DEPARTMENT OF HEALTH AND HUMAN SERVICES

January 11, 2007
HETA 2006-0004

1A.1 **Summary of Work.** The work described consists of furnishing all necessary materials, labor, equipment, tools and supervision to remove and replace portions of the airport traffic control tower drywall. The project is located in Romulus, Michigan.

DTW ATCT MOLD REMEDIATION PROJECT CLEARANCE PROTOCOL

DETAIL A - PARTITION WALL
(2 HOUR FIRE RATING)
NOT TO SCALE

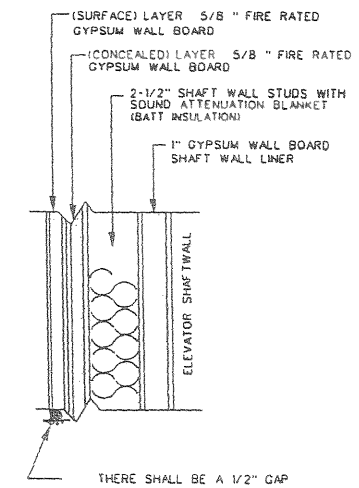
THERE SHALL BE A 1/2" GAP BETWEEN THE BOTTOM OF THE GYPSUM BOARD AND THE CONCRETE DECK. THE GAP SHALL BE FILLED WITH A 2-HR FIRE-RATED CAULK

DETAIL B - INSULATED FIRE RATED ACCESS PANEL FOR WALLS
(1 1/2 HOUR FIRE RATING)
NOT TO SCALE

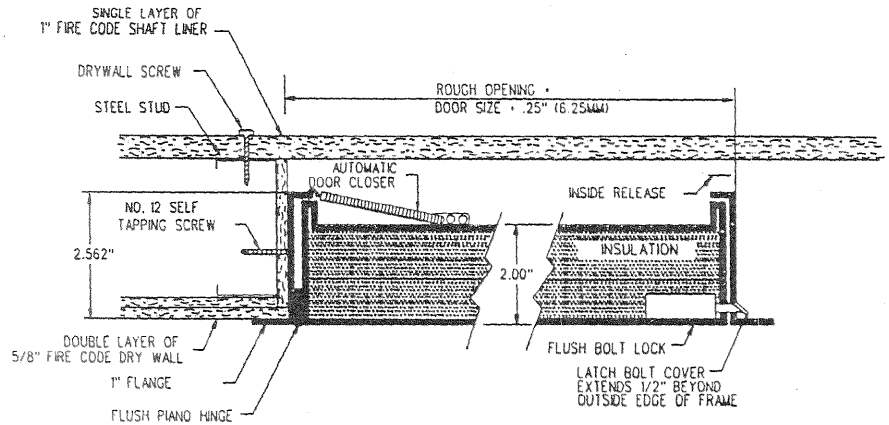
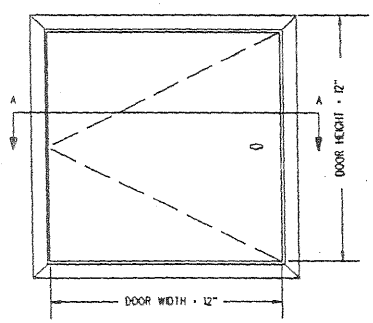
7. Paint elevator core exterior and stairwell corridor with mold resistant paint.
8. Furnish and install fire-rated access panels in the center of the north and east elevator core wall. The bottom of the panel shall be 24" above the floor. Do not penetrate the shaft liner. See detail "B" on drawing DTW –D-ATCT-A11.
